September 7, 2016 **Team Memo # 0051**

To All F4 Teams

Please see attached the following updates from Crawford

Bulletin F4.02.08.24

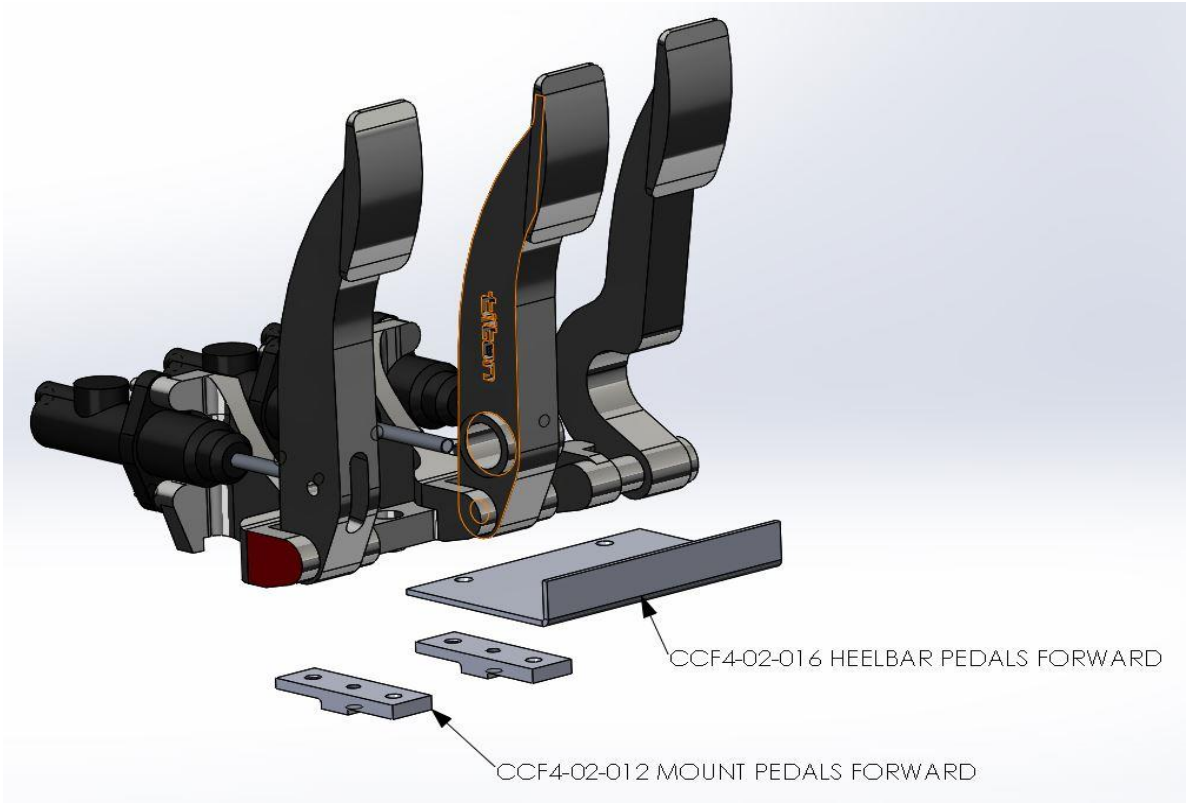
1 **Mount to move pedals forward 1.12 "**

Steel mount to move pedals forward 1.12"
Mounting hardware supplied with kit to use first pair of holes in chassis
Requires tall steering column, and mount tall steering sensor

Steel mount	CCF4-02-012 MOUNT PEDALS FORWARD
Heelbar	CCF4-02-016 HEELBAR PEDALS FORWARD
Steering column	CCF4-04-020 ASSEMBLY TALL COLUMN STEERING
Sensor mounting	CCF4-04-022 MOUNT TALL STEERING SENSOR

Bulletin F4.02.08.26

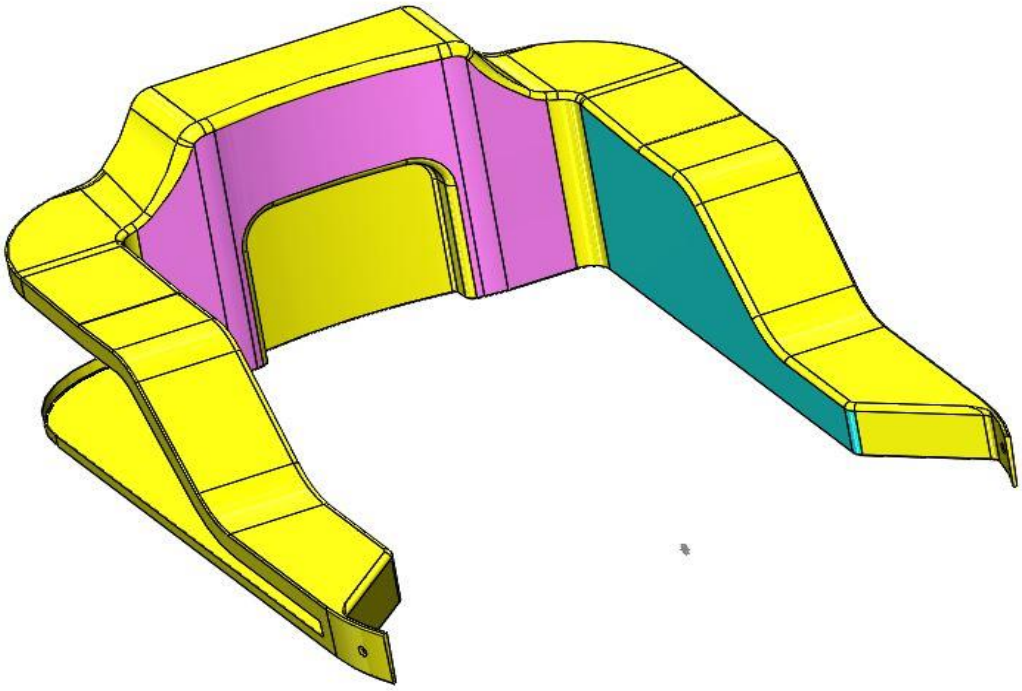
1 **Headrest updated to give more clearance for taller drivers**

Updated headrest will give more room for taller drivers
and increased clearance for the HANS device
All future headrests will be to this specification
This part has FIA homologation

Parts
Headrest CCF4-02-001_2 HEADREST Rev 2

Bulletin F4.05.08.24

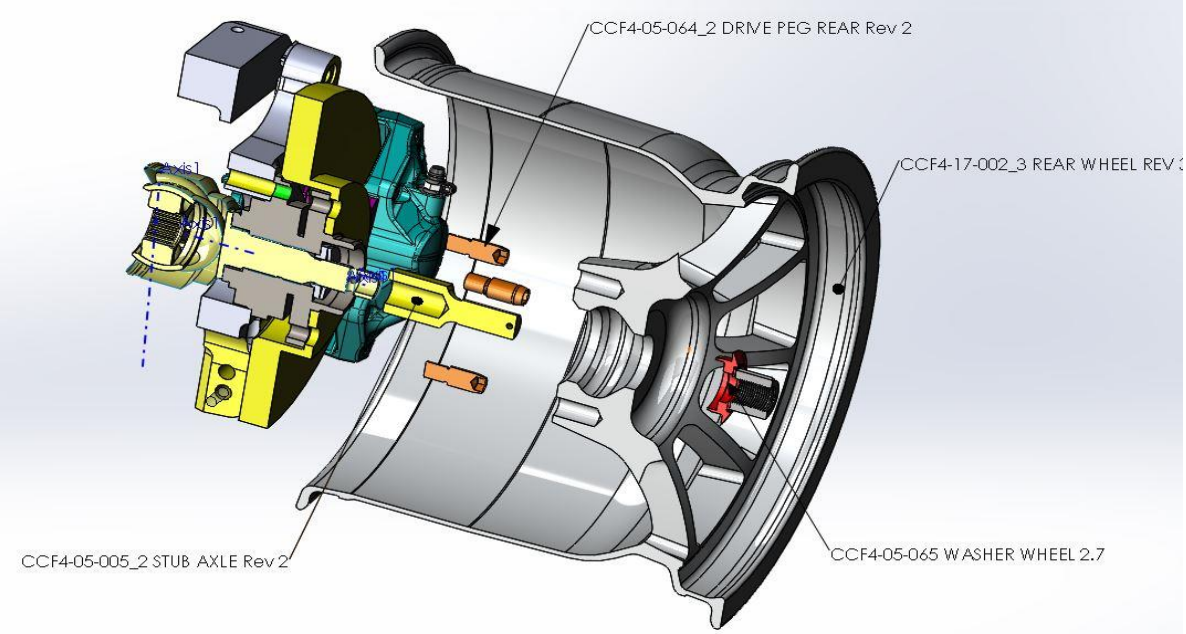
1 **Manufacturer required update**

Safety critical item

Crawfords to update all rear wheels - drive pegs - stub axles - wheel washers

Rear Wheels	CCF4-17-002_3 REAR WHEEL REV 3	2
Drive pegs	CCF4-05-064_2 DRIVE PEG REAR Rev 2	8
Stub Axle	CCF4-05-005_2 STUB AXLE Rev 2	2
Wheel washer	CCF4-05-065 WASHER WHEEL 2.7	2
